RESPONSE TO ENVIRONMENT AGENCY OBJECTION

Proposal: Conversion and Subdivision of Warwick Mill to 135 No. Apartments (Use Class C3) and Flexible Commercial Space (Use Class E) Including Works of Demolition and Formation of Interior Atria, Parking at Lower Ground-Floor Level and Demolition of London House and Erection of Building to Provide 146 No. Apartments (Use Class C3) (281 Total), and Flexible Commercial Space (Use Class E) Formation of External Car Parking, Public Realm, Landscaping, Alteration to Existing Vehicular Access and Creation of Additional Vehicular Access to Oldham Road (A669) and Associated Internal and External Additions and Alterations

We write in response to the consultation comments received on 14th February 2024 (reference SO/2023/123448/02-L01) in regard to the proposed development at Warwick Mill, Oldham Road, Middleton, M24 1AZ. Each of the points raised in the Environment Agency letter are reproduced in *black italic text* below, with our response in [blue text](#) beneath.

Figure 1: Proposed 1 in 100 year plus 35% climate change maximum depth, wet/dry and proposed minus baseline difference plot.

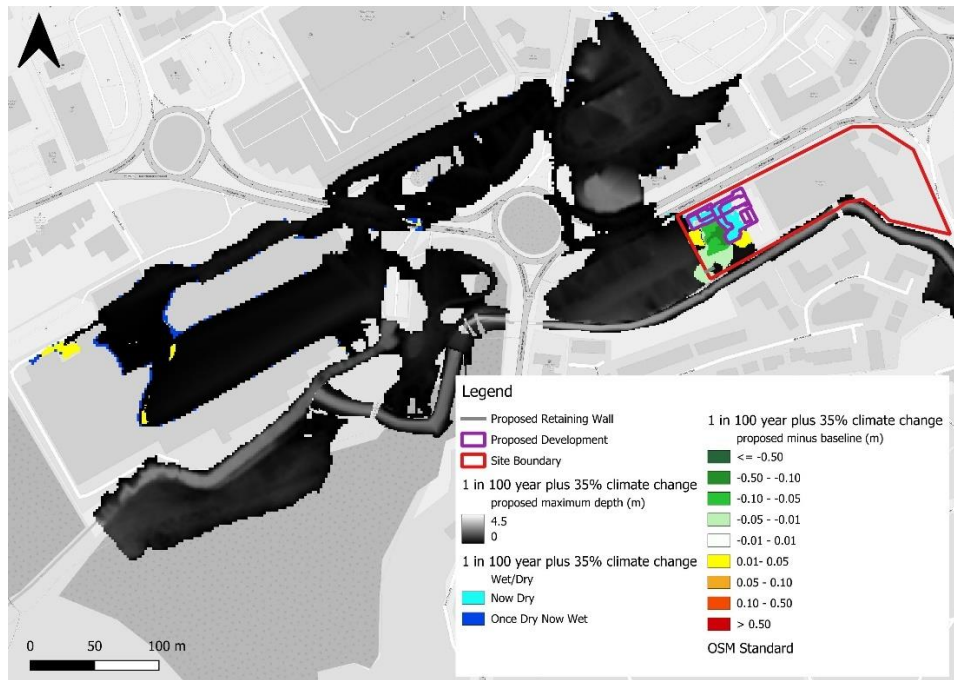
We note the discussion in section 9 regarding the river modelling that has been undertaken. The results presented in tables 2 and 3 regarding baseline and post development flood levels are largely within the site boundary. They do not show potential change outside the boundary although there is reference to change elsewhere in paragraph 9.14. This states that there would be increases in flood levels downstream of 20-25mm.

The difference maps show small scale ‘patches’ of increased depth at the McBride site; these are minimal in magnitude (<0.025m) and scale – see [Figure 1](#). These ‘patches’ occur only in the 1 in 100 year plus 35% climate change event; they are not apparent in the 1 in 75 year and 1 in 100 year events. The increases in flood depths are within and on the edge of an already extensive floodplain extent. See **Error! Reference source not found.** showing the proposed 1 in 100 year plus 35% climate change event flood extent with the 1 in 100 year plus 35% climate change depth difference at the McBride site.

Figure 2: Flood depths and flow arrows showing movement of floodplain flows across the site (1 in 100 year plus 35% climate change event)

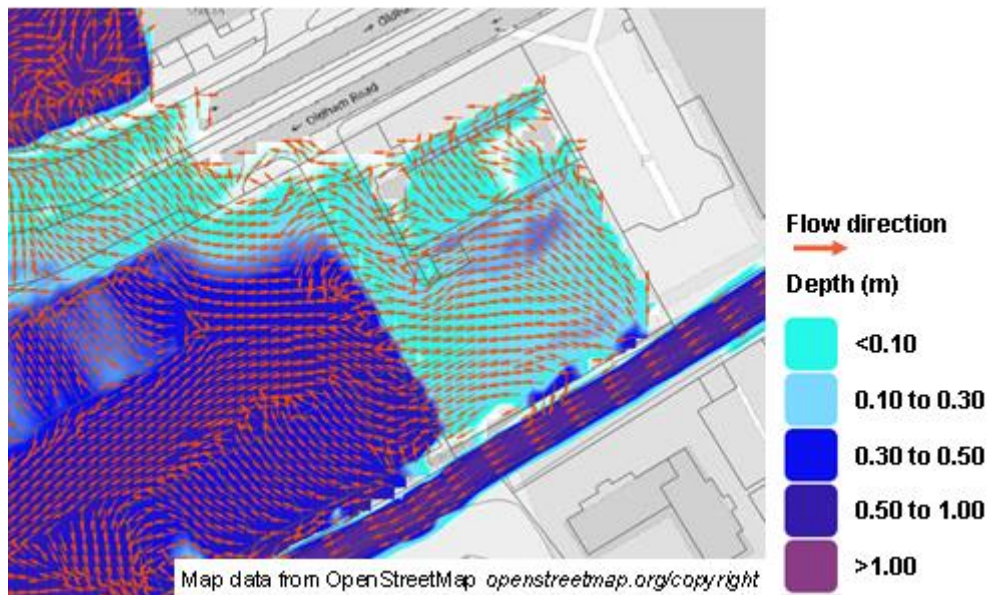
The report states "Overall the proposed development results in no significant increase in flood risk to off-site receptors". The increase would appear to be due to ground level raising for the proposed "Loom" development without provision of any compensatory flood plain storage. This is contrary to the NPPF and the guidance in PPG paragraph 049.

Formal level for level compensation calculation have not been undertaken for the proposed development because this type of calculation does not accurately reflect the true nature of flood storage on the site, nor recognise the nature of the flooding mechanisms across and within the vicinity of the site and how this is changed by the proposed design.

Level for level compensation approach is appropriate in cases where the mechanism of flooding comprises water spilling out of bank directly onto the site where it accumulates and is stored as a volume of floodplain with a flat surface (uniform maximum flood level). However these principles do not apply in this case as the site itself is in a flow path (see Figure 2); as such there is continuous movement of water through the site and this is reflected in the sloping nature of the floodplain (non-uniform maximum flood levels).

This understanding of the particular nature of flooding mechanisms was one of the primary drivers for undertaking hydraulic modelling exercise because such an approach is far more accurately able to capture the complex movement and storage of flows within the whole hydraulic system compared to a site-limited level for level compensation calculation exercise. The hydraulic modelling exercise and results are able to capture the flooding mechanisms more accurately and are therefore better able to demonstrate the impact of the proposed design on flood storage and flood risk on the site and wider area.

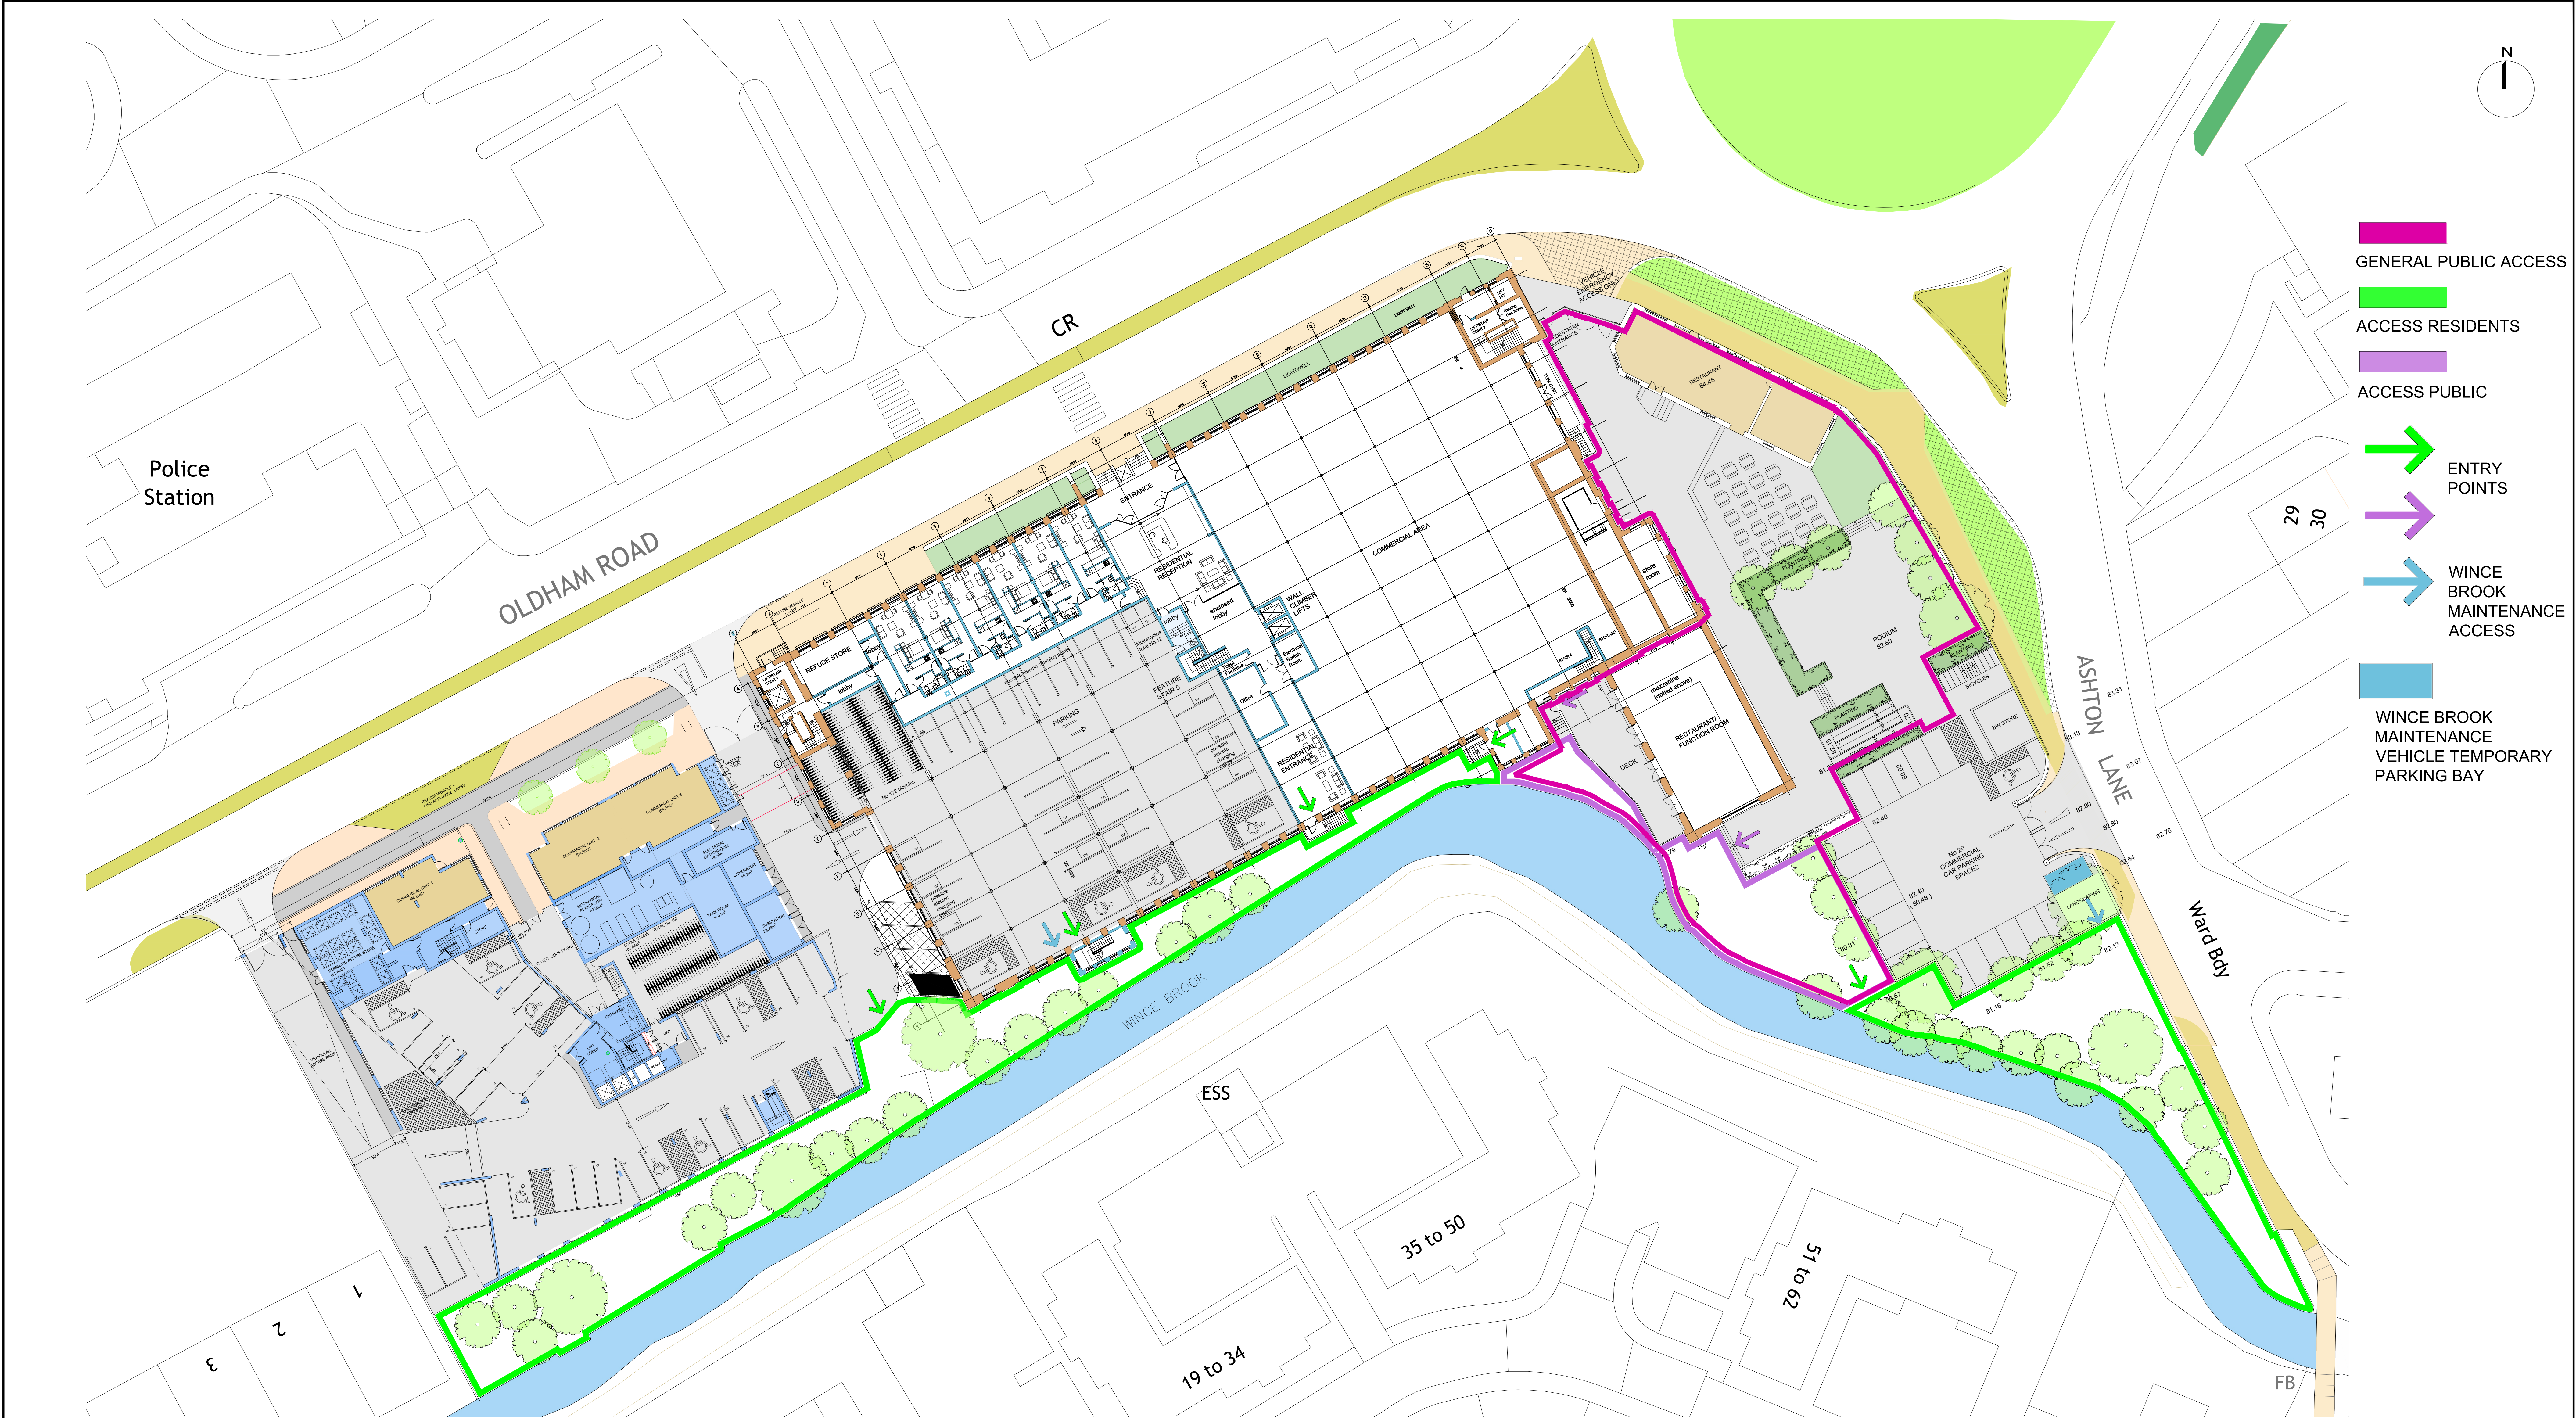
There is no additional information to clarify whether the proposals will retain any access provision to the bank top of Wince Brook. The plans show a green buffer to the channel, but it is not clear whether pedestrian and/or vehicle access would be possible and if so, via what route. Clarification of the proposed developments, proximity to the bank top of Wince Brook and available access points to the watercourse should also be provided. The provision of occasional vehicular access to the bank top should be identified.

A plan is appended which identifies the access points and confirms pedestrian and vehicular access to the brook bank top will be provided.
